Key Largo Wastewater Treatment District
Board of Commissioner's Meeting
Tuesday, December 6, 2022
4:00 PM

Change Order No. 1 for Collection System Monitoring Project

Re: KLWTD Collection Monitoring System- Change Order #1

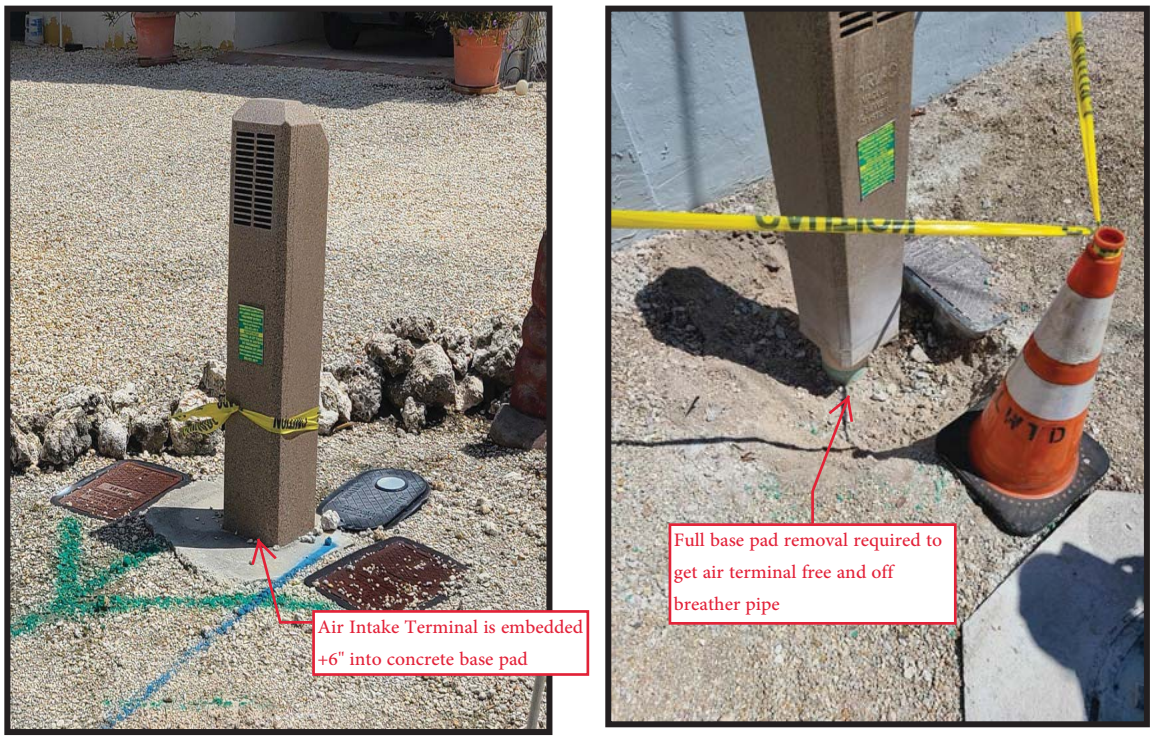
The first issue encountered was the thickness of the house keeping pad under the air intake terminals (tombstones). Typically, these housekeeping pads are expected to be 4”-6” thick with minimal reinforcement which is what was planned for as part of the Collection System Monitoring project. However, in Basin D it was quickly discovered that the housekeeping pads were 16”-24” thick. This thickness meant that FloVac’s plan of under excavating the pad and coring a hole for the 2”conduit through it would no longer be possible as it would require drilling through +16” of concrete.

As can be seen in the pictures above, the concrete had to be chipped out in order to get the conduit installed. In Basin D there were 205 of the 240 pits that required this additional chipping work.

Embedded Air Intake Terminals:
The second issue encountered was that some of the air intakes were embedded approximately 6" into the concrete housekeeping pads and could not be removed without breaking the pad apart. As with the aforementioned pads, these were also 16"-24" thick but because of the embedment it required full removal of the pad to complete the installation of the FloVac sensors & conduits.

The picture above (left) shows an air intake terminal embedded in the concrete. The other picture above (right) shows the terminal after the pad has been removed. In Basin D there were 35 terminals that were discovered to be embedded in the concrete which require full removal of the pad.

Summary of Two Main Field Conflicts:
As discussed above, in Basin D 205 of the 240 total air intake terminals were poured too thick and required additional effort for the Contactor to install the system. Additionally, 35 of the 240 air intake terminals were embedded approximately 6" into the concrete which required full pad removal resulting in additional effort. This additional effort was beyond what was expected based on project records and design standards. The contractor should be compensated for the work beyond the original scope of the project.

Galvanized Air Terminal Support Rod:

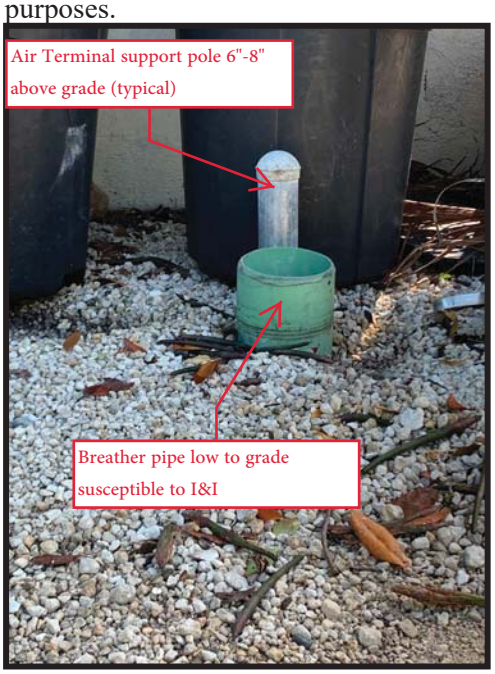
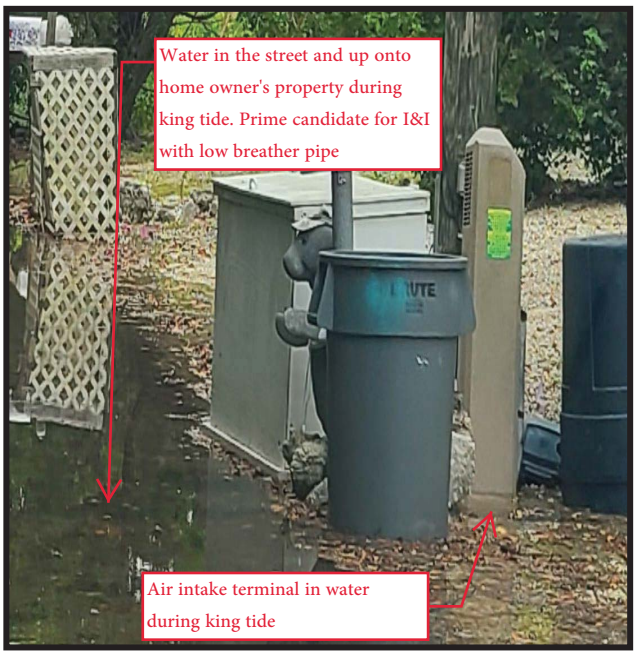
Another potential storm hardening effort that was identified is the support rods for the Air Intake Terminals. Currently these supports are made of a 1"-1.5" galvanized hollow tube like that would be used in chain-link fence construction. Many of these supports currently only extend 6-8" above the grade which is very little support to the intake terminal especially during a flood event.

In order to address this WEC is proposing that a #7 (7/8") galvanized rebar be driven into the center of the existing support and into caprock with an embedment of approximately 3ft. This will provide a much stronger support for the terminals to resist flood loadings. While it may not save all the terminals from damage, it will reduce the number of damaged ones during a large storm event which will lessen inflow and infiltration into the system.

Based on information from the KLWTD staff it is estimated that approximately 2300 (80%) of the existing supports are in the 6-8" range and should be extended for system hardening purposes.
